NORTHERN STATES POWER COMPANY

MONTICELLO NUCLEAR GENERATING PLANT
Docket No. 50-263 License No. DPR-22

Supplementary Information Regarding the First Monticello Reload

CYCLE 2 CORE
MONTICELLO

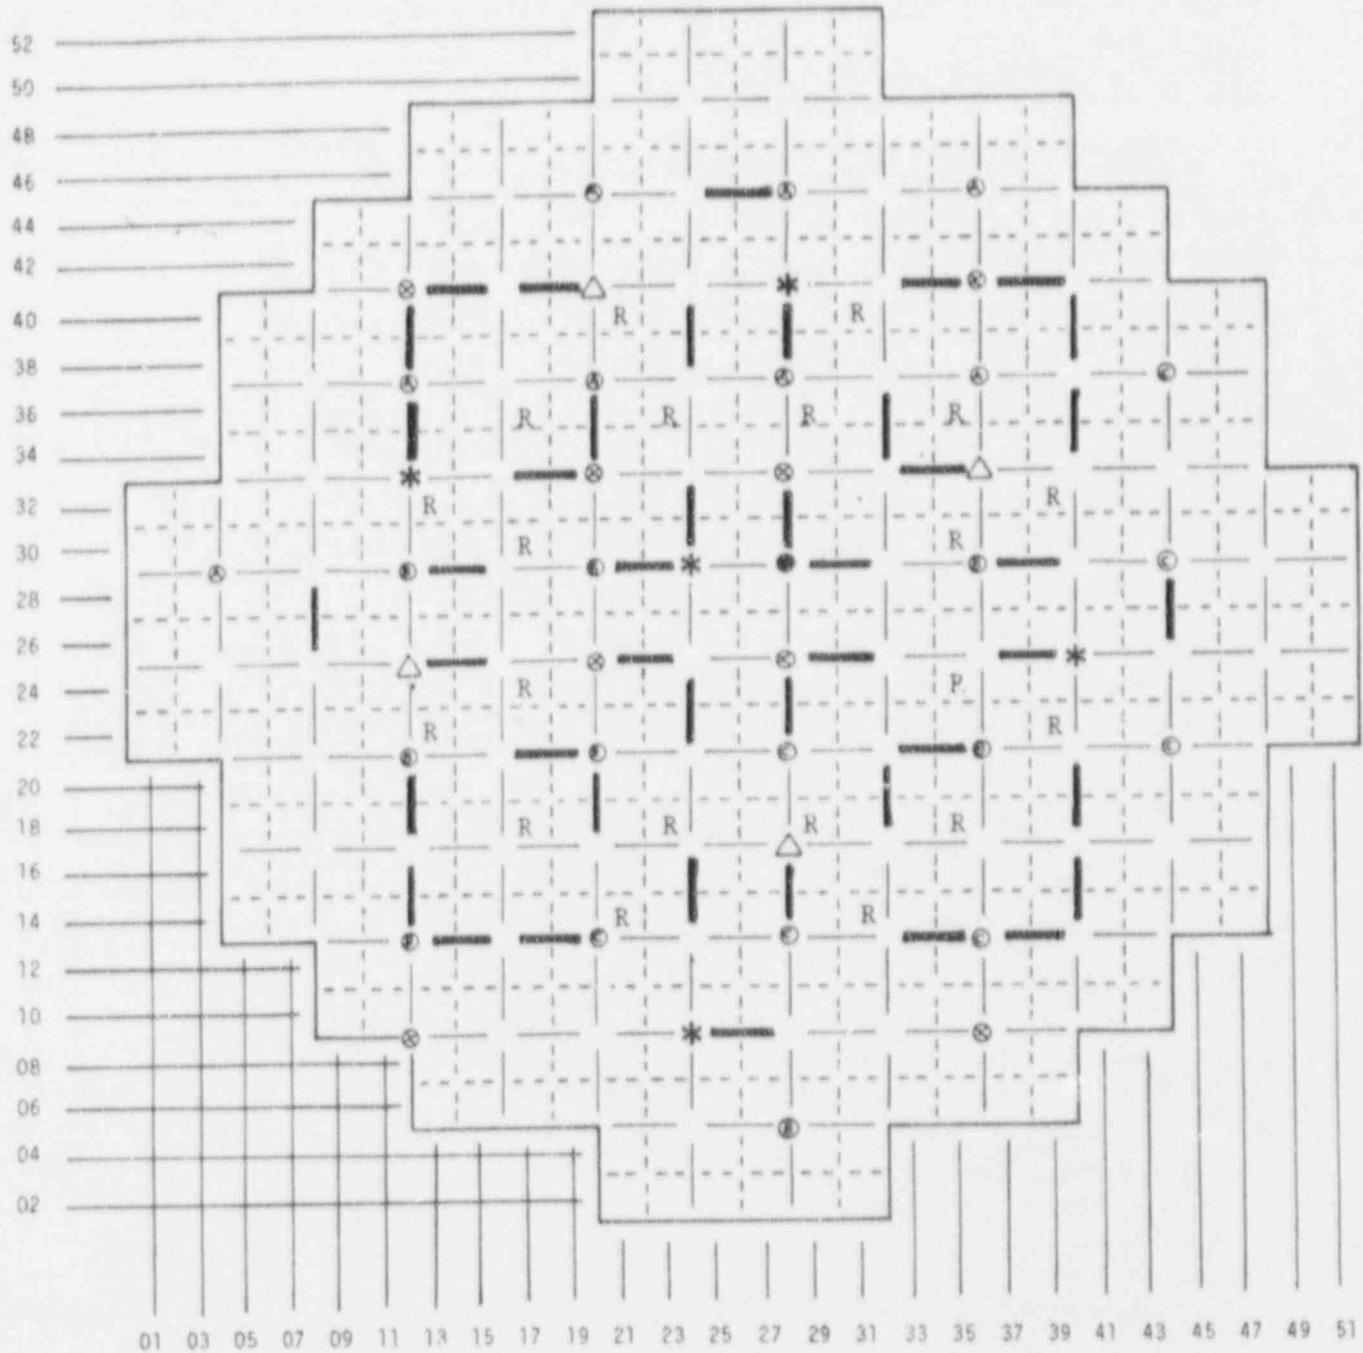
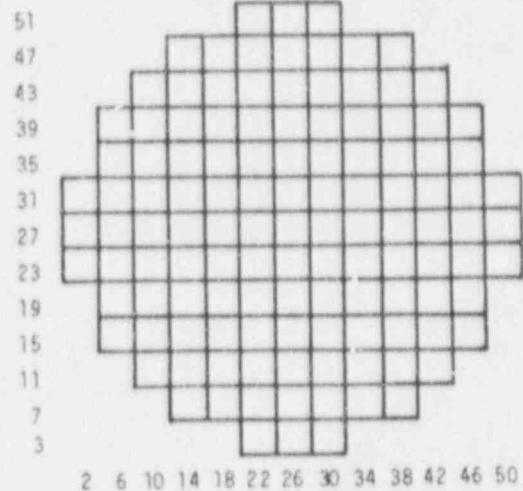
On February 20, 1973 we submitted a document entitled "First Reload License Submittal." Calculations performed in support of that document were based on a target exposure of 6800 MWD/STU. The plant capacity factor exceeded the estimate, resulting in an exposure of approximately 7100 MWD/STU at the date scheduled for the outage. We, therefore, intend to modify our previously reported plans somewhat to reflect the achieved cycle 1 exposure.

The reference core discussed in the initial submittal consisted of 28 R-1 type reload fuel assemblies with 456 initial core fuel assemblies having a preoutage average exposure of 6800 MWD/STU and 64 temporary control curtains. Allowable deviations of these parameters were also discussed to establish a window for the outage. Because exposure exceeded this window, a revised core loading plan has been selected which is compatible with existing exposure conditions. Our present plan is to load a cycle 2 core consisting of 20 R-1 type reload fuel assemblies with 464 initial core assemblies and 44 temporary control curtains. The shutdown margin for this core with the rod of highest worth fully withdrawn is calculated to be 0.015 delta k which is well in excess of the 0.01 delta k design requirement stated in the FSAR. The attached figure shows the planned cycle 2 core.

The safety analysis presented earlier has been reviewed, found to be unaffected by this change in core loading and found not to involve an unreviewed safety question. The Monticello Operations Committee and Safety Audit Committee have reviewed the revised loading plan.
